Case #H 94-19. #2 Cerro Gordo. Downtown and Eastside Historic District. David M. Tighe, agent for Joe Pytka, proposes selective window and door replacement, restuccoing at casitas #1 and #2.

Case #H 94-20. 1103 Canyon Road. Downtown and Eastside Historic District. Justin Greene, agent for Dirk Wales, proposes installation of 2'-4" x 4'-0" window at north elevation of previously-approved project.

HISTORIC DESIGN REVIEW BOARD APPLICATION FORM

memo

NORTH/PATRICK SMITH PARK ELE

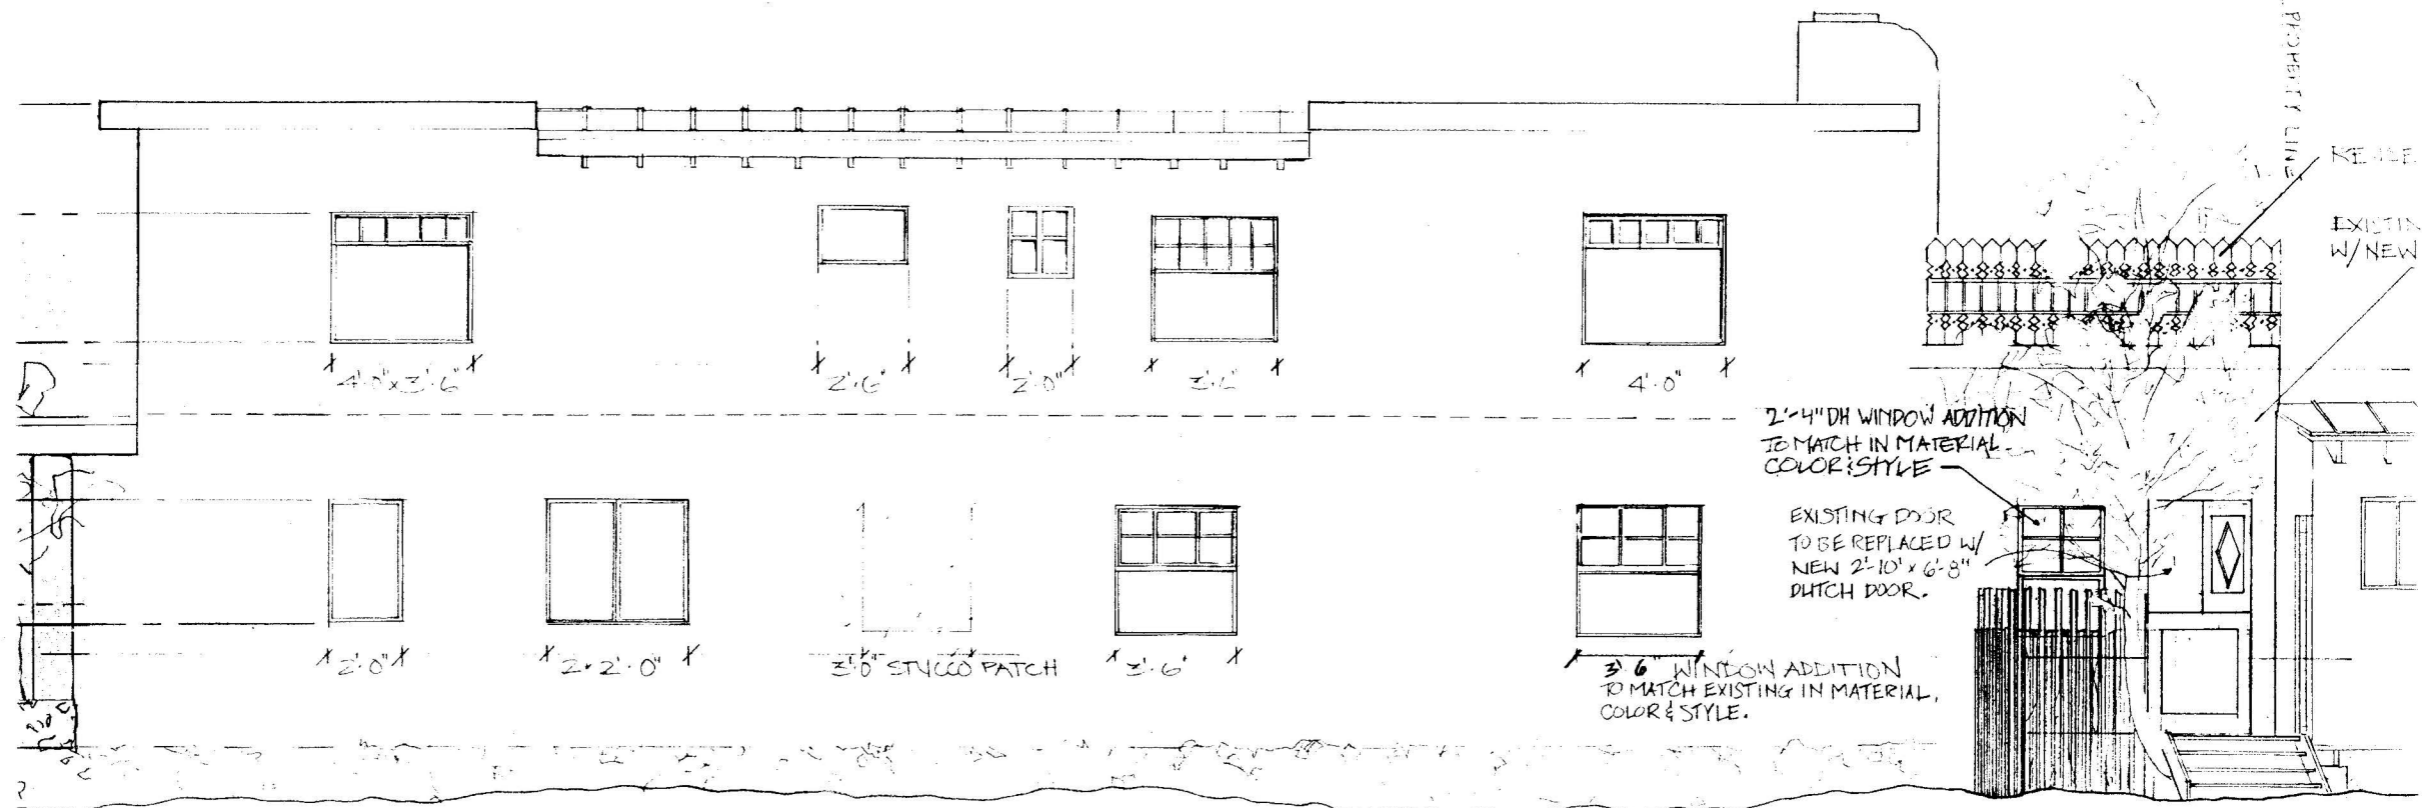
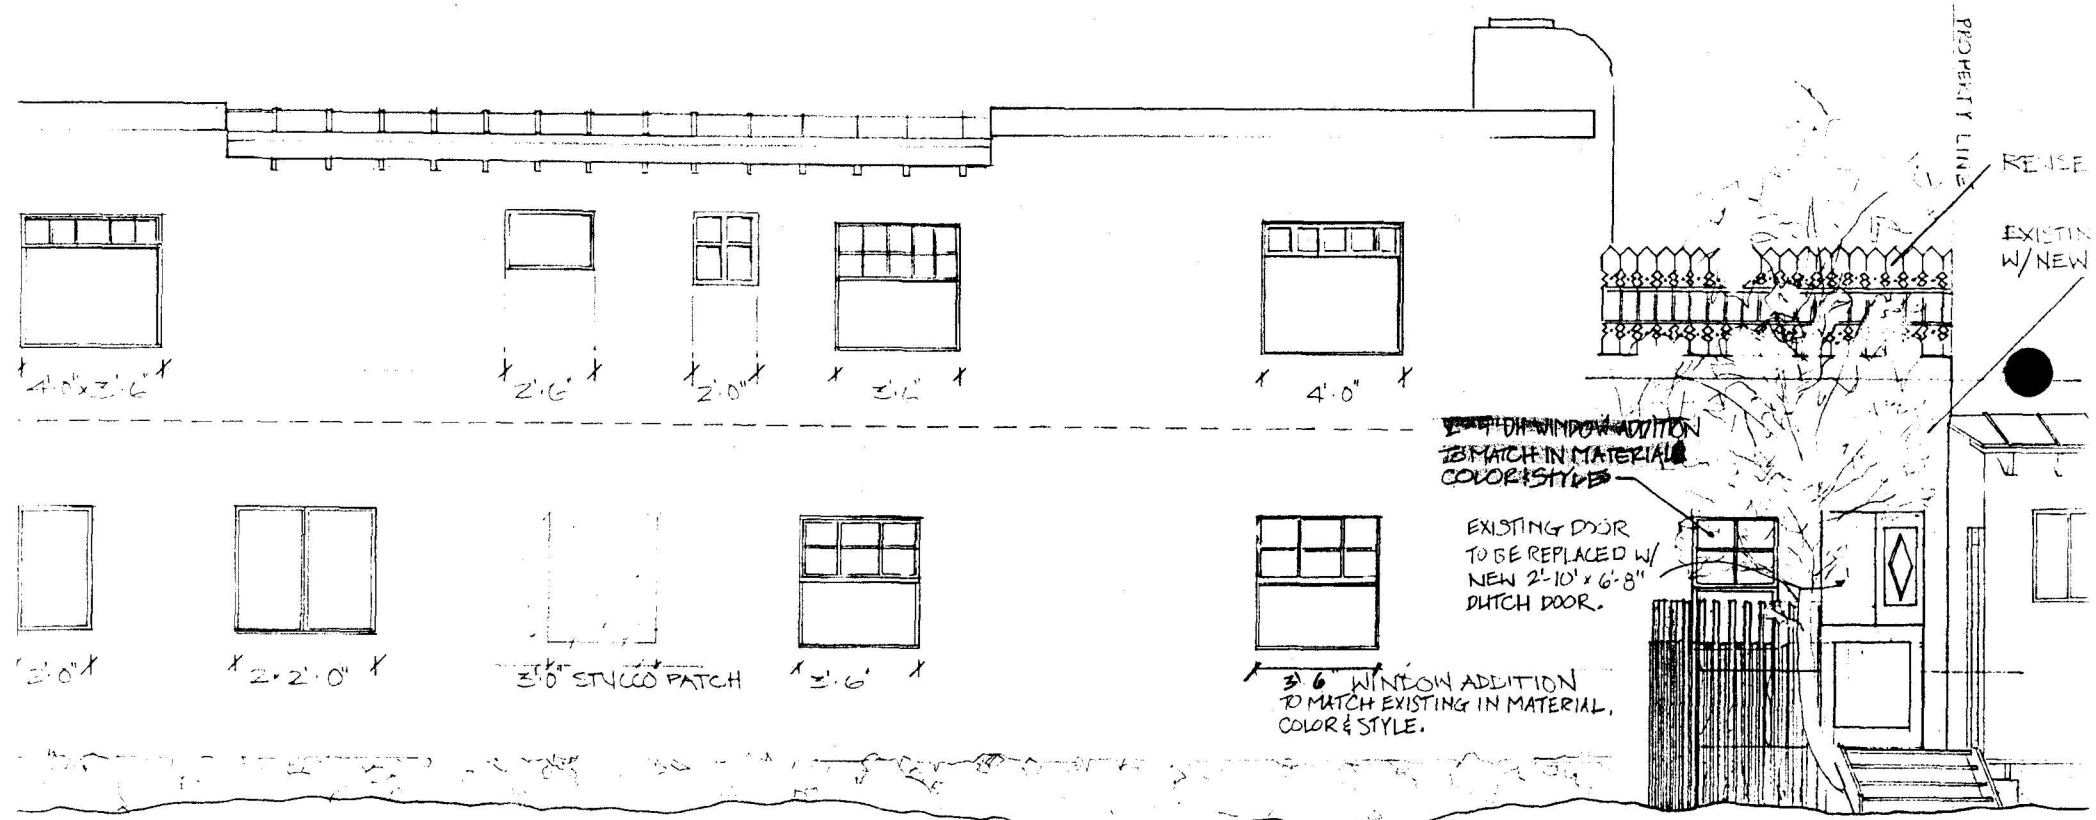
This is a request to the H.D.R.B. for consideration of the installation of an additional window on the north/Patrick Smith Park side(elevation) of 1103 Canyon Rd. We are currently well underway with the previously approved design (Aug '93).

The window we are proposing is 4'-0" high and 2'-4" wide. The height is in keeping with the vertical dimension of the existing windows on the park elevation. The wall in which it is to be installed was previously thought to be made of masonry, however, it is literally a lath and stucco wall connecting a small butress that extends from the main structure of the house to the partywall. This discovery brought out questions about the "contributing" value of the wall as well as a desire to be able to bring light in from the park. In the process of installing this window we would also be able to strengthen and insulate this section of the north wall.

Ms. Rivera moved for approval of Case #H 94-20 as submitted. Mr. Cohen seconded the motion and it was passed by unanimous voice vote.

This is to certify that the Historic Design Review Board at their meeting on February 8, 1994, acted on the above referenced case. The decision of the Board was to (X) approve, () conditionally approve, () table, () deny your request. You shall make part of your Building Permit application any conditions imposed by the Board which are listed as follows: _____
